Product Change Notification / NTDO-28XWRK640

CCB 4758 Initial Notice: Qualification of MPHL as additional final test site for selected ATSAMA5D2xx device family in 289L LFBGA (14x14x1.4mm) package.

CCB 4758
Pre and Post Change Summary
PCN #: NTDO-28XWRK640

Carrier Tape for T/R

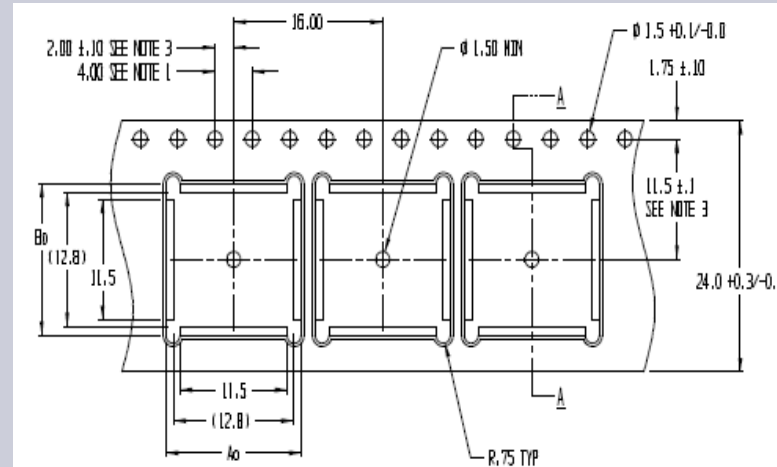
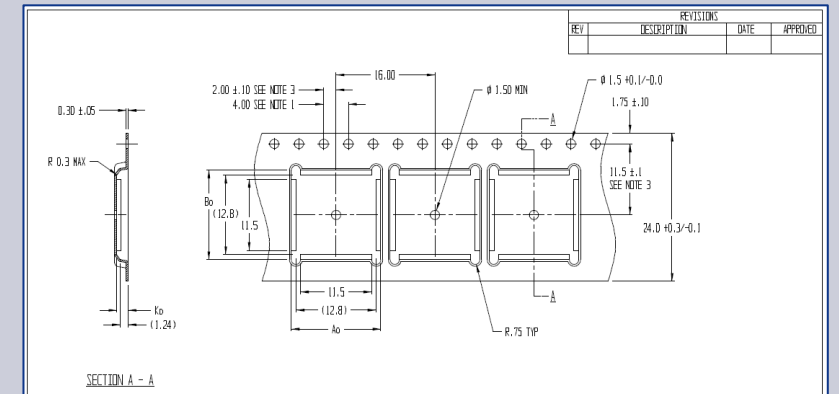
Width (mm)	Pitch (mm)	A0 (mm)	B0 (mm)	K0 (mm)	Thickness (mm)
24	16	14.5	14.5	1.84	0.3

Width (mm)	Pitch (mm)	A0 (mm)	B0 (mm)	K0 (mm)	Thickness (mm)
24	16	14.5	14.5	1.84	0.3

Cover Tape for T/R

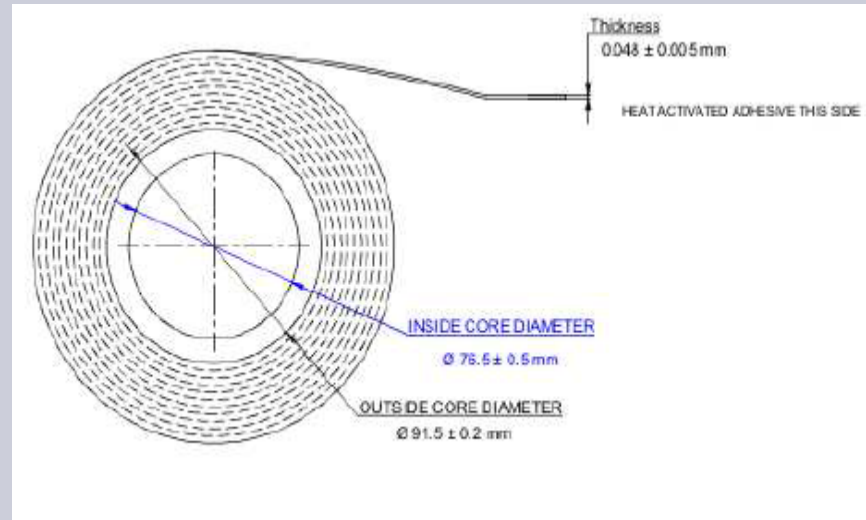
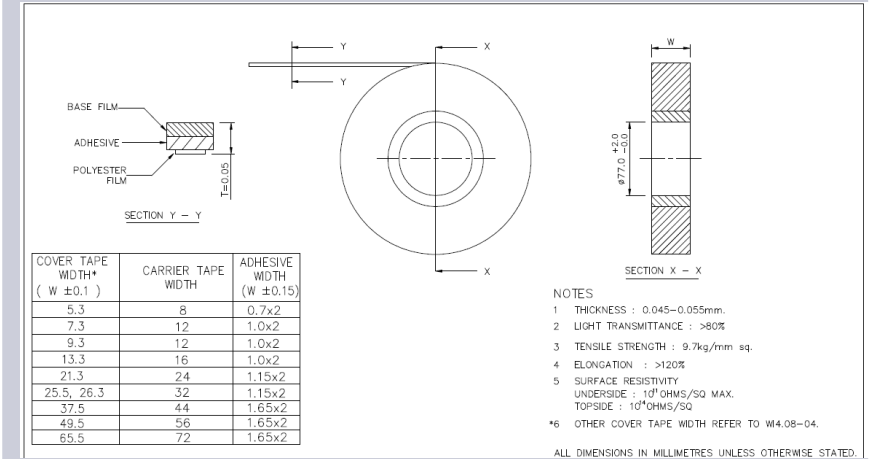
Carrier Width	Cover Tape Width (mm)	Thickness (mm)	Sealing Methodology
24	21	0.048	Hot Press

Carrier Width	Cover Tape Width (mm)	Thickness (mm)	Sealing Methodology
24	21.3	0.05 +/- 0.0005	Pressure Seal Activate

Plastic Reel for T/R

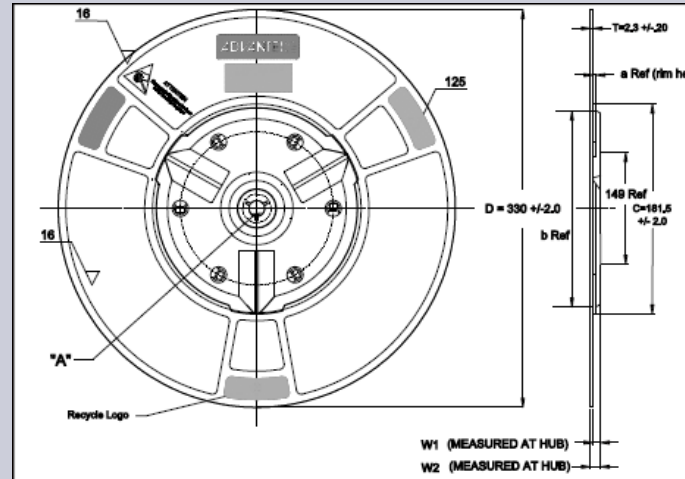
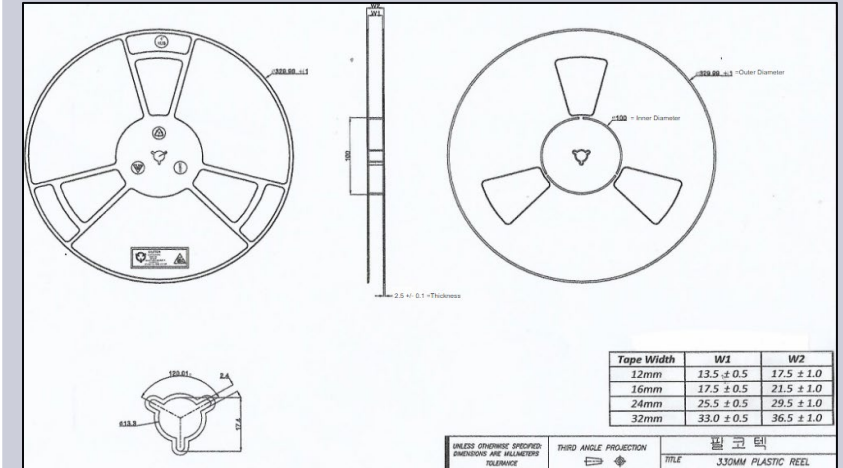
For Carrier Tape Width	Diameter	Hub	Color
24	330	181.5	White

For Carrier Tape Width	Diameter	Hub	Color
24	330	101.6	White
